REED REVISED PLAN - DEP 300-1127

PLAN DATE: 2/17/22	
DWG NUMBER 21046	
REV. 3	
SHEET 1 OF 2

Soil Absorption System - "Upgrade"
 Located At: 88 SOUTH SHORE ROAD
 Sturbridge, Massachusetts
 For: Steven B. Reed & Marcy L. Reed

PROPOSED SITE PLAN

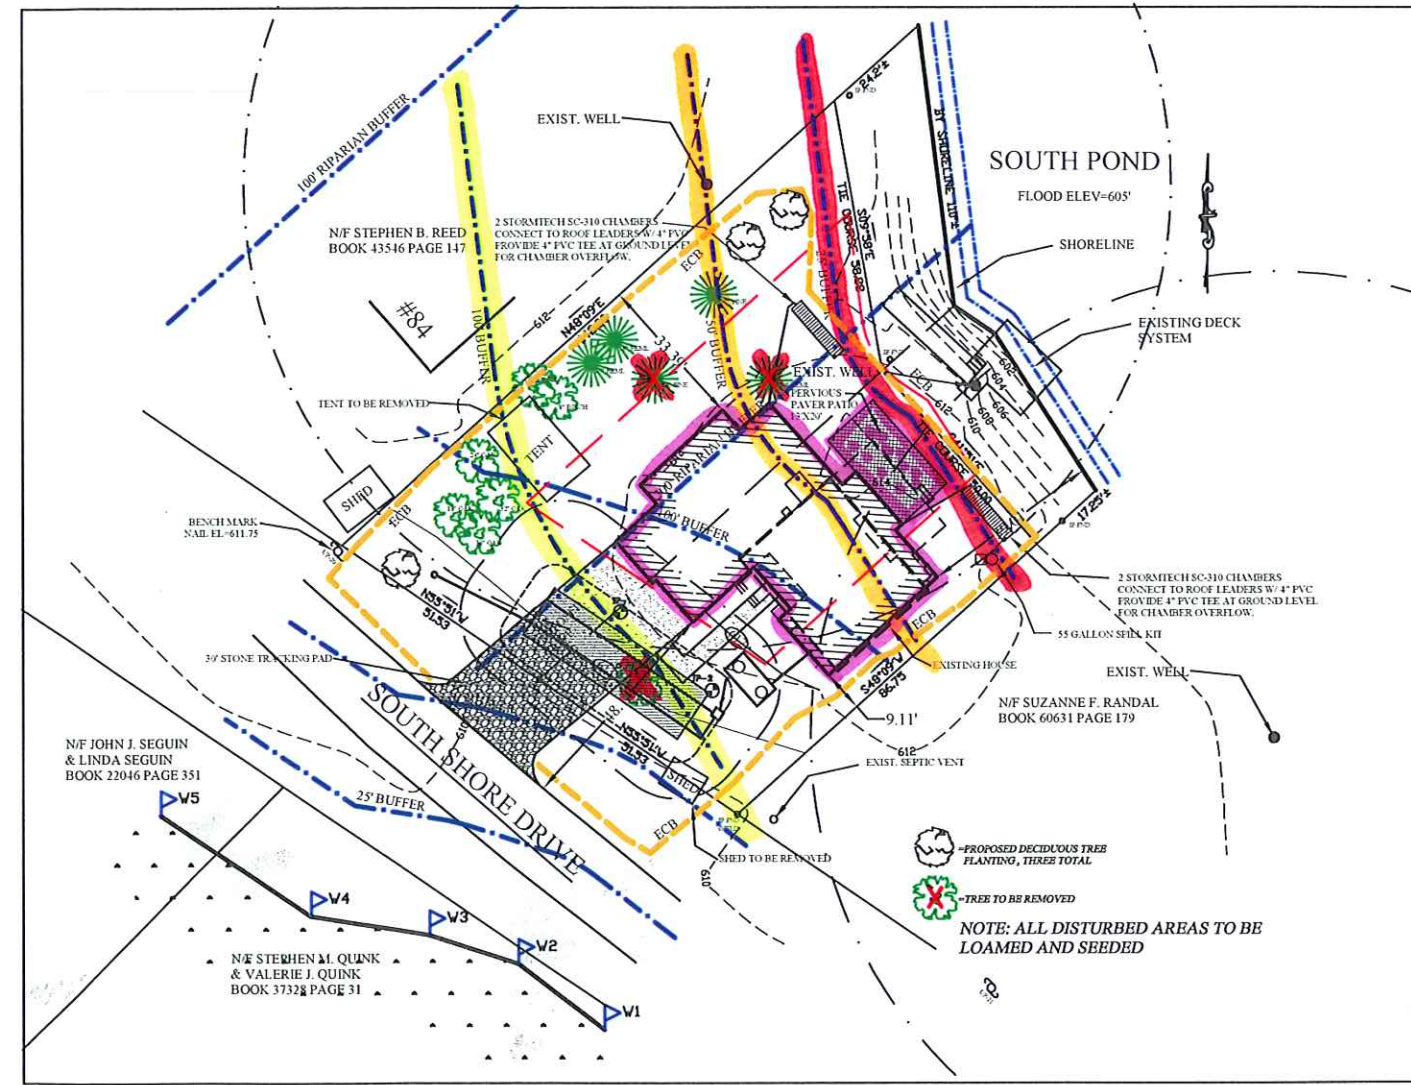
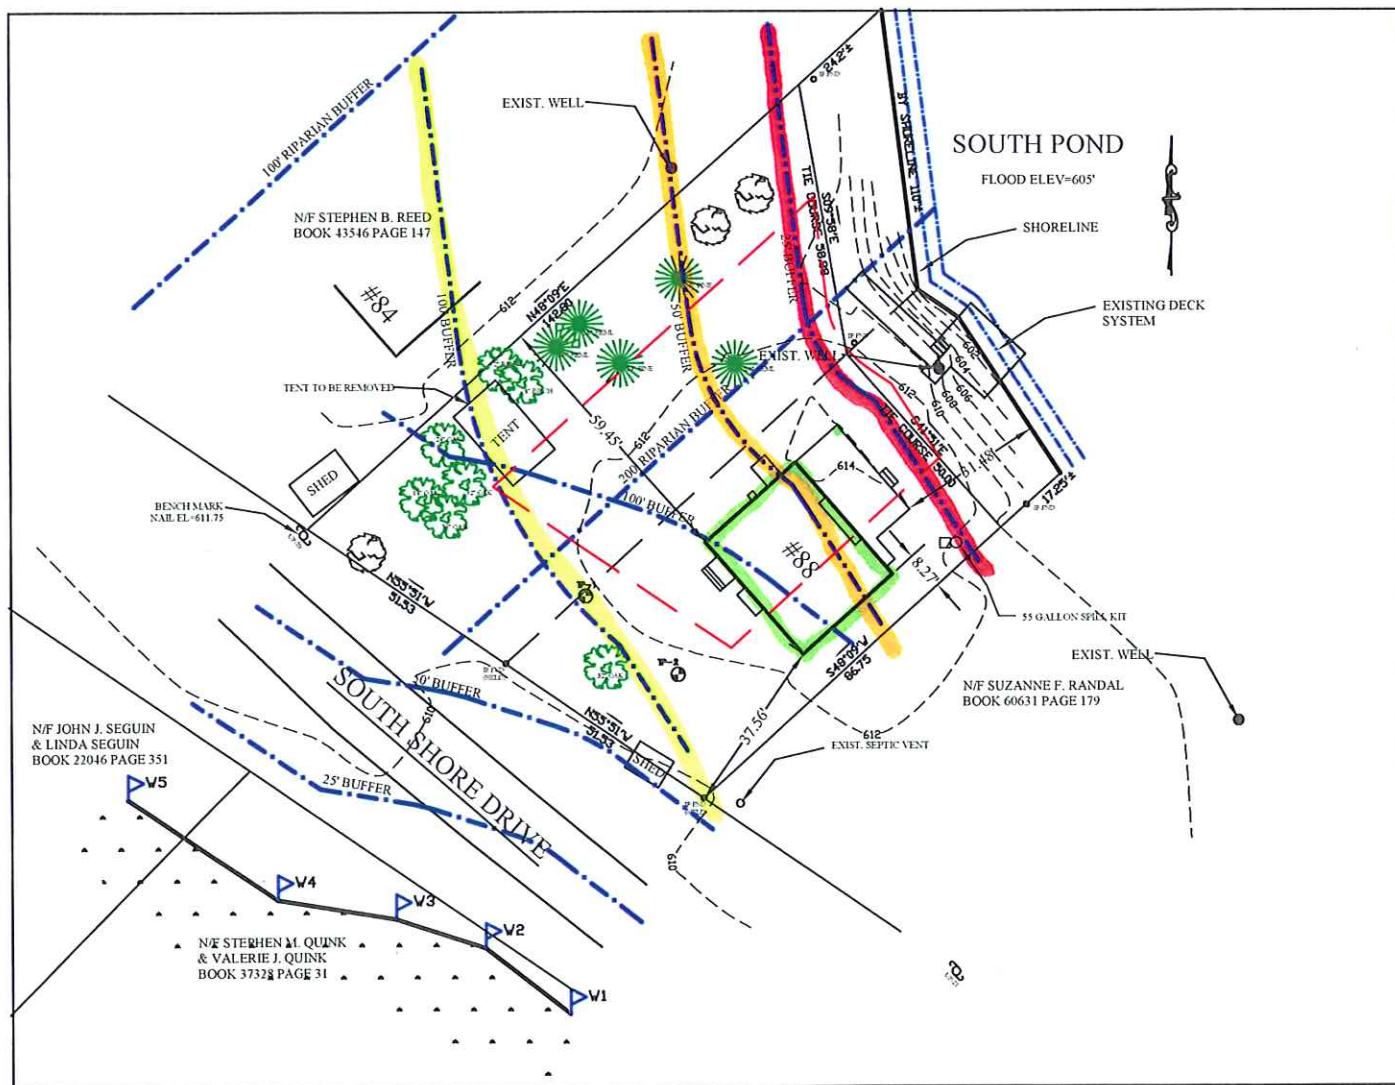
BUILDING COVERAGE WAS REDUCED TO 2,061 SQ.FT FROM 2,497 SQ.FT. A REDUCTION OF 436 SQ.FT FROM THE PROPOSED LAYOUT ON 4/21/22. THE REDUCTION IS 17.46% OFF THE ORIGINAL PROPOSAL. THE PROPOSED BUILDING WAS RELOCATED 12.15' WESTERLY ONTO THE EXISTING SETBACK LINE OF THE EXISTING STRUCTURE. THIS ALLOWED FOR A REDUCTION OF 508 SQ.FT OUT OF THE OUTER LIMITS OF THE RIPARIAN BUFFER ZONE. THE ALTERATION NOW IS 132 SQ.FT BETWEEN THE 100 FT AND 200 FT LIMIT. THIS IS A REDUCTION OF 85% WITHIN THE RIPARIAN ZONE. THE EXISTING HOUSE HAS 186 SQ.FT WITHIN THE 50'-25' ZONE. THE PROPOSED ADDITION HAS 218 SQ.FT ADDITIONAL AREA WITHIN THE 50'-25' BUFFER.
